## Addendum # 1

For the Bid of  
Cedars Cold Storage- 2023  
FM12302  
22828 E. Canyon Rd.  
Cataldo, Idaho 83810  
5/22/2022

From: Miller Stauffer Architects  
601 E. Front Ave. Suite 201  
Coeur d'Alene, ID 83814  
Ph (208) 664-1773  
Fax (208) 667-3174  
Website: [www.millerstauffer.com](http://www.millerstauffer.com)

**A1.0**

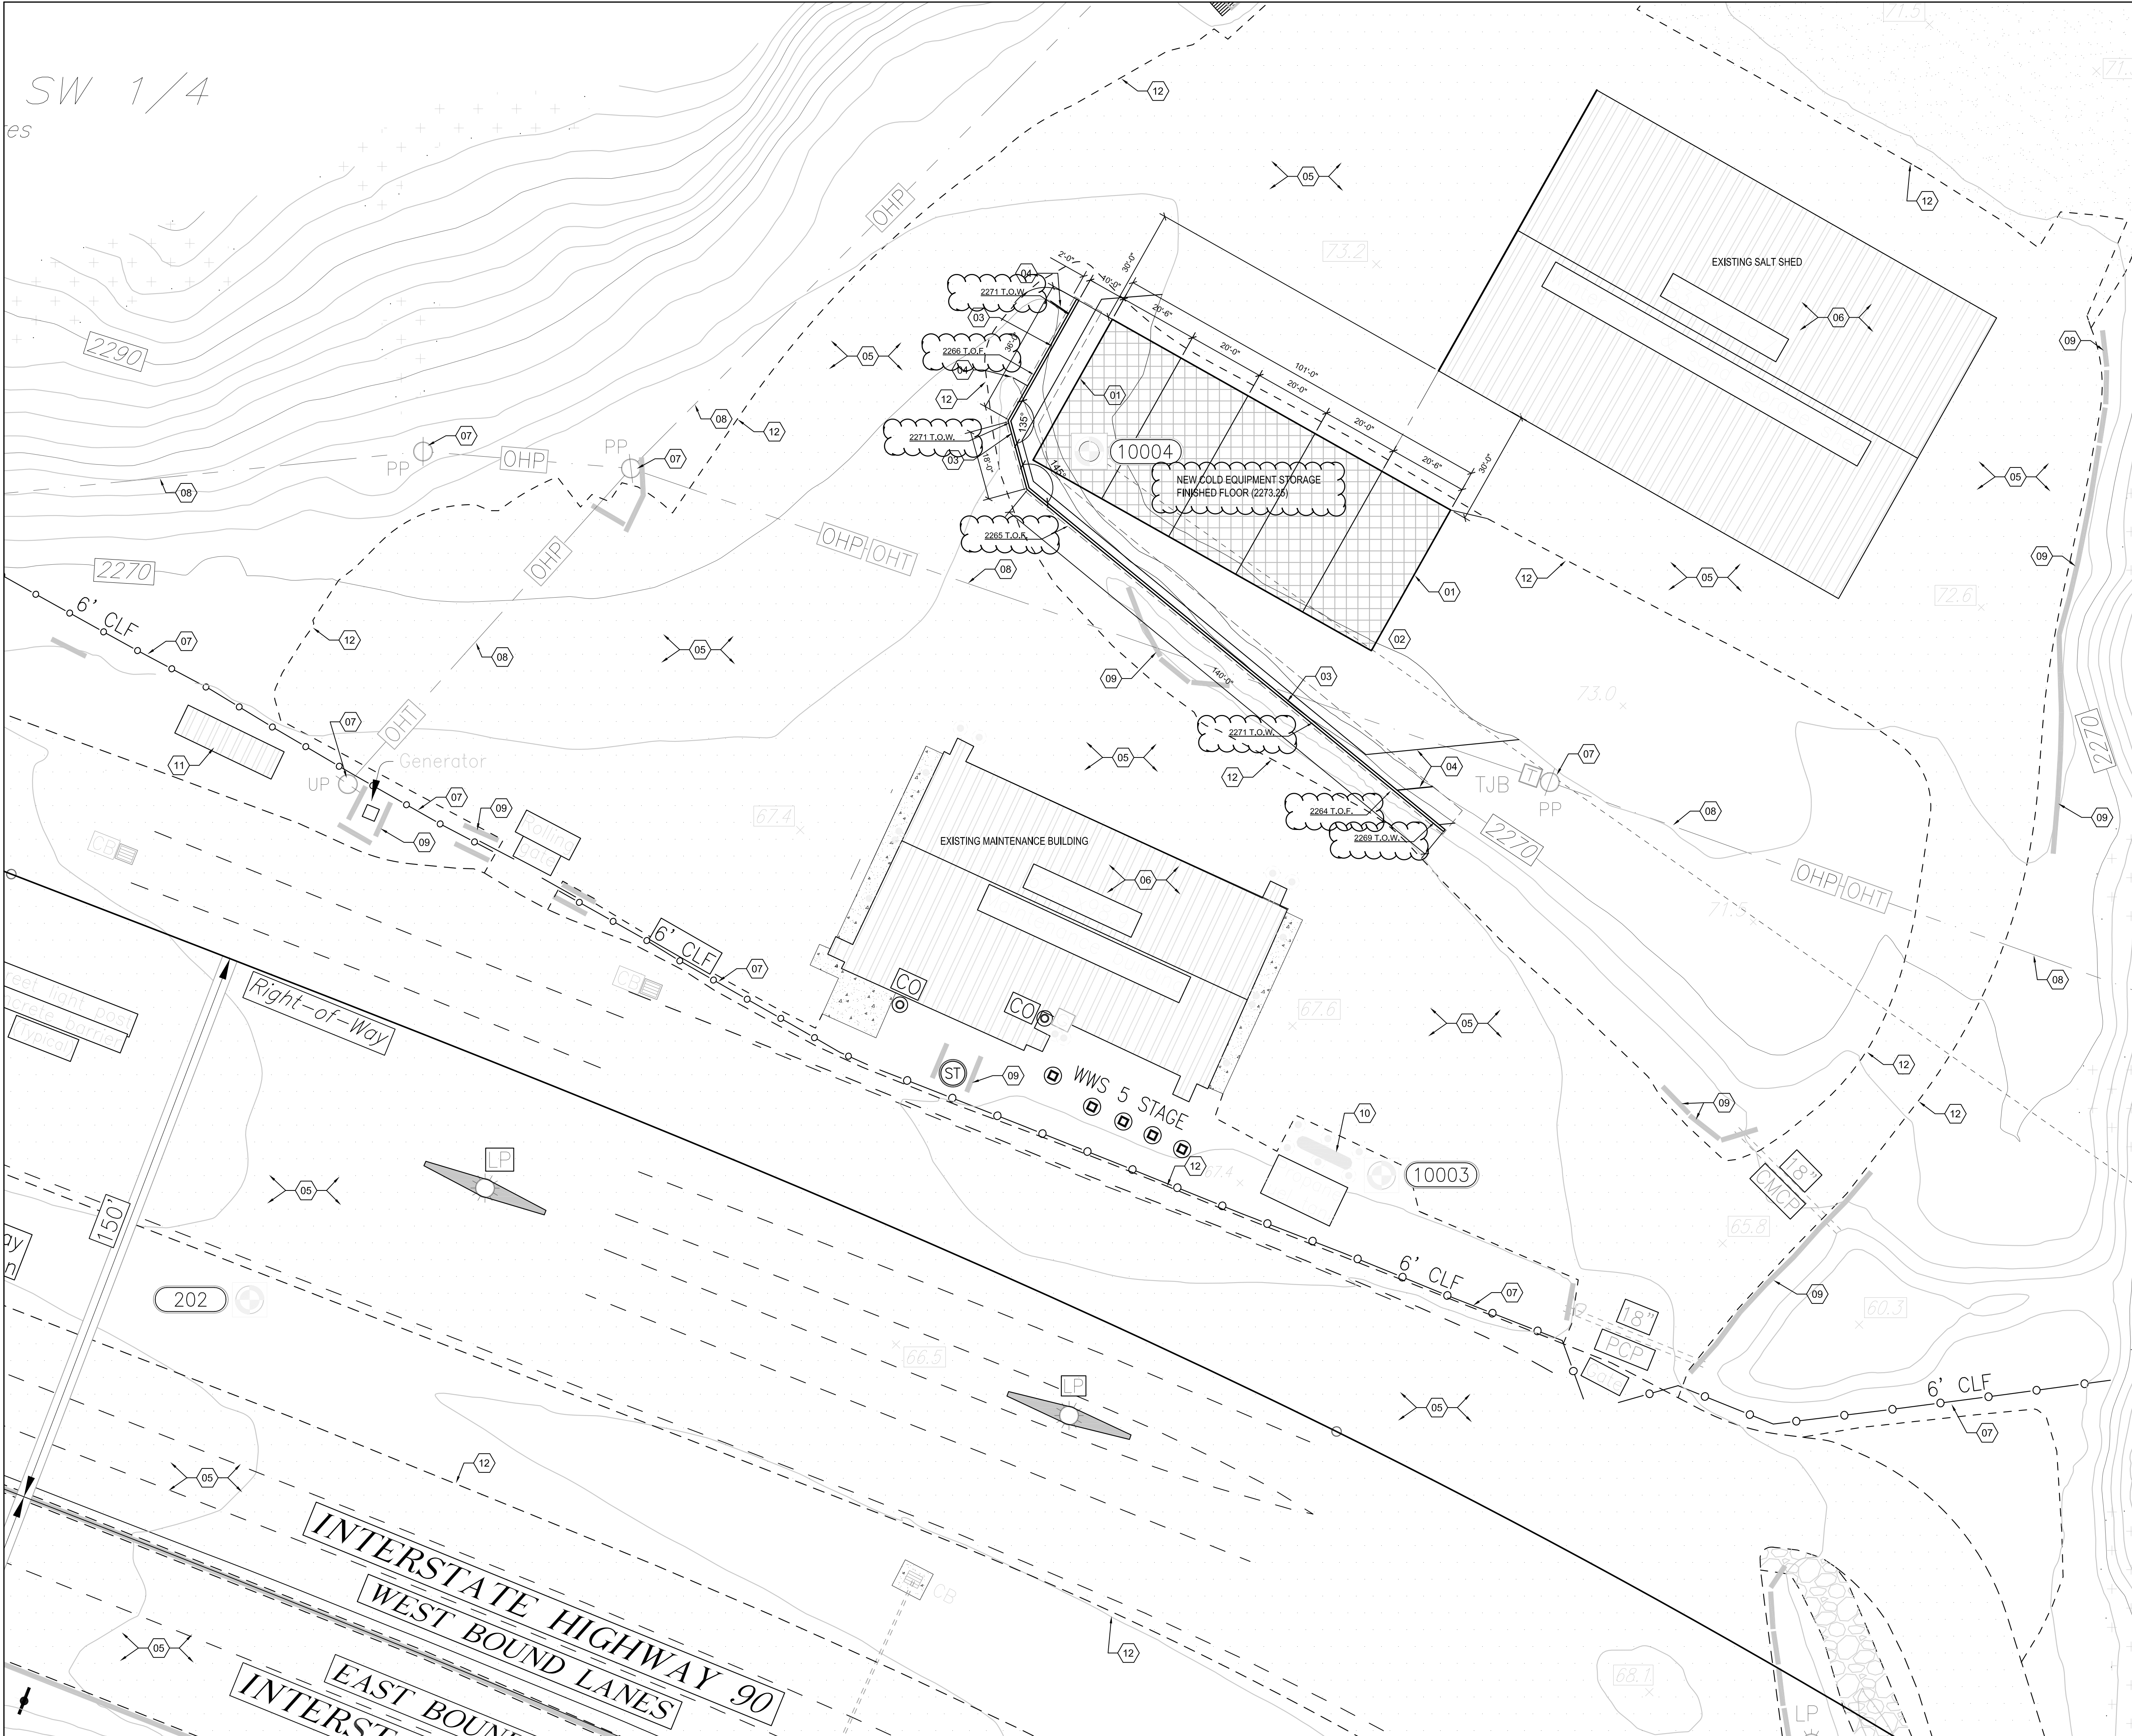
- viii. Frost Depth: 28"
2. Drawings
- a. Additions
    - i. None
  - b. Deletions
    - i. None
  - c. Revisions
    - i. A1.0 Site Plan
      - 1. Changed Finish Floor Elevation to 2273.25.

- 2. Added Top of Wall (T.O.W.) and Top of Foundation (T.O.F.) Elevations. See attached A1.0 Site Plan.
  - d. Substitutions
    - i. None
3. Specifications
